**Report on Consultation (Routeing Stage)**  
**Connagill Cluster Grid Connections**  
**April 2024**

**REF: LT559, LT560, LT319, LT522, PT961 and  
LT421**

LT319: Armadale Wind Farm Grid Connection  
 Figure 2.1 - Viewpoint from Armadale Broch Scheduled Monument

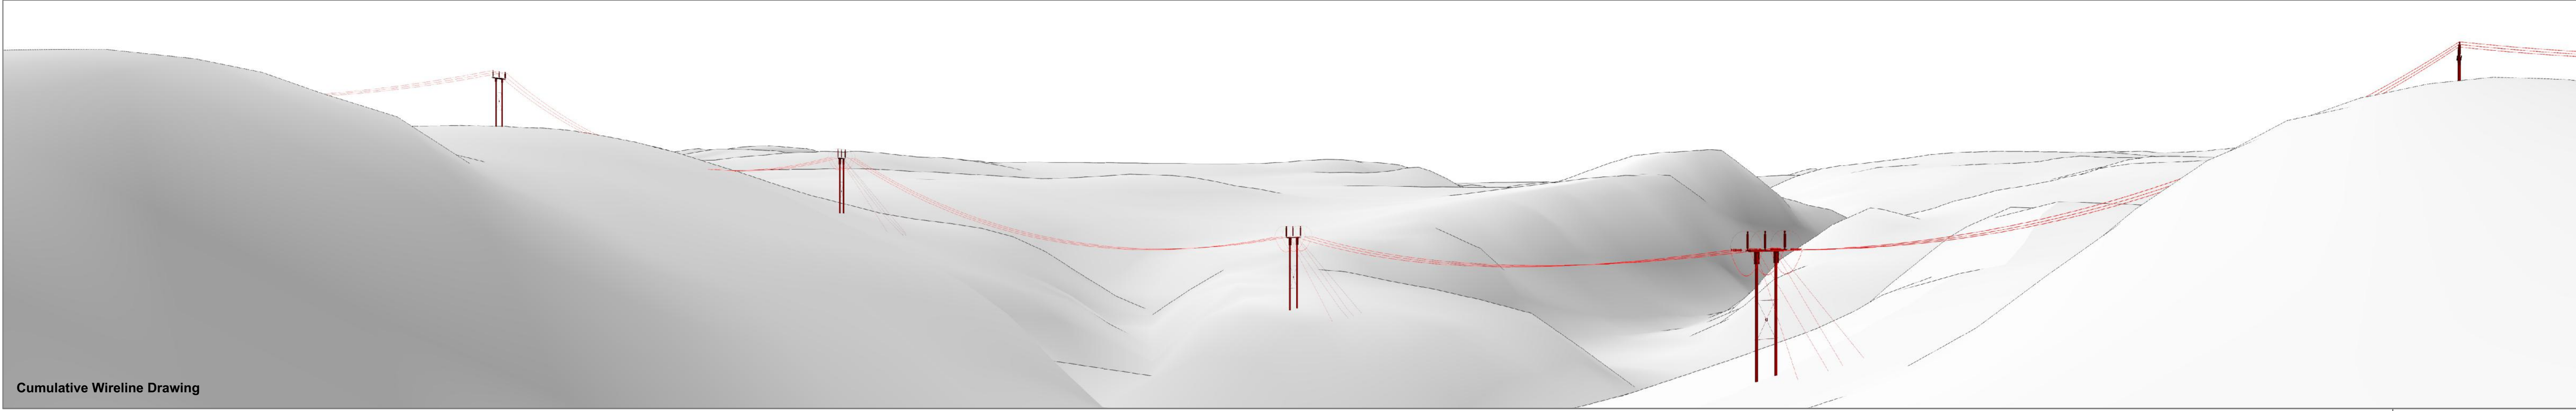
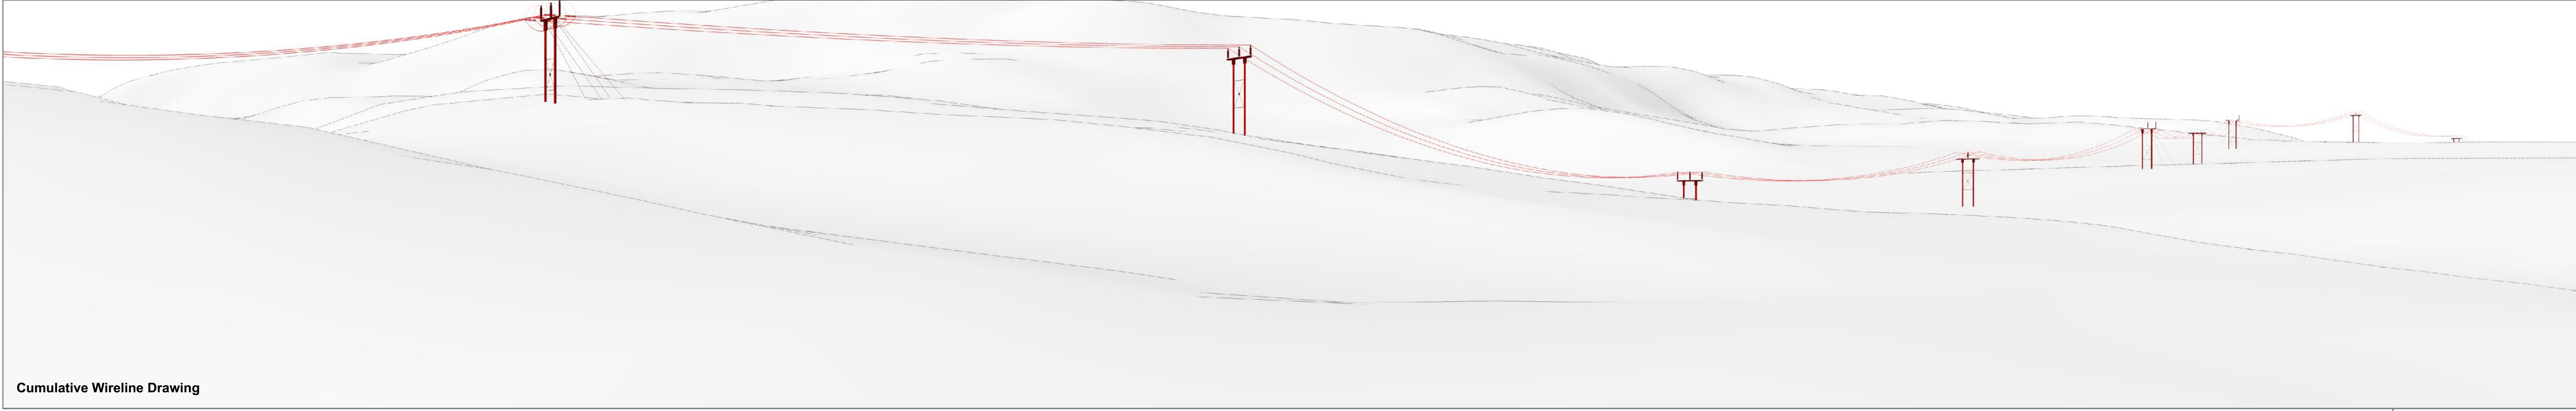
The rationale given in the Consultation Document for the choice of Route Option A-4 is that the view north from the broch, along the gorge of the Armadale Burn, would be left open and this was identified as a key view. It also states that views to the west, from which the OHL would approach the broch, are not significant. HES disagree with this assessment. The flatter, lower-lying land to the west across the Blàr Dubh is a key aspect of the broch's setting and is considered important. The preferred route would be in very close proximity to the broch, with the corridor indicated for Route Option A-4 putting the OHL between 20 m and 230 m from the southern edge of the monument. At this distance, the proposals could have a significant adverse effect on the integrity of the monument's setting by introducing a distracting and imposing structure into a landscape in which the broch is currently both dominant and striking in its isolation.

Route A4 also takes a path across the Blàr Dubh. Consequently, it would be very visible in views out from the broch and, because of its orientation, would likely appear to divide the Blàr Dubh in two. Views towards the broch would also be significantly affected, particularly as the trackways currently crossing the Blàr Dubh towards the broch would pass under the OHL at various points. The OHL would therefore seriously disrupt the currently unobstructed view towards the broch from across this plain, undermining its prominence and stature as a lone and imposing structure overlooking this landscape.

Given the proximity of the proposals to the scheduled monument and the impacts on key aspects of the setting of the broch, it is likely that they would have an adverse

<p>impact on the integrity of the setting of the monument and raise issues of national interest.</p> <p>We therefore recommend that other route options are explored as alternatives to Route Option A-4. The other routes considered in the Consultation Document would likely have a lesser impact on the setting of Armadale Burn broch. While all of the other routes would cross the Armadale Burn to the broch’s north, the impact would be less severe and would be affecting a less important aspect of the broch’s setting.</p> <p>Route A1a is furthest from the monument and would therefore likely have the least impact on the setting of the scheduled monument, followed by Route A2. Although Routes A1b, A3a, and A3b are closer to the monument, they are still further away than Route A4 and would affect a less sensitive part of the monument’s setting.</p> <p>The potential impacts on the setting of Armadale Burn broch from any of the proposed routes should be assessed in detail by experienced heritage professionals.</p> <p>Visualisations will be required to demonstrate the impacts of the proposals in the setting of the scheduled monument. These should be taken from the summit of the broch and from a location on the Blàr Dubh plain at around NGR NC 79383 62628.</p>

In relation to Armadale Broch scheduled monument, a visualisation of an indicative OHL supported by trident H-wood pole within the optimal route, was prepared by SSEN Transmission and shared with HES ahead of the meeting in March (see **Figures 2.1-2.2 and 2.3 to 2.5**).

The visualisation displays that there would be limited views to the west (across Blàr Dubh), which was flagged as an important part of the broch's setting by HES, albeit the
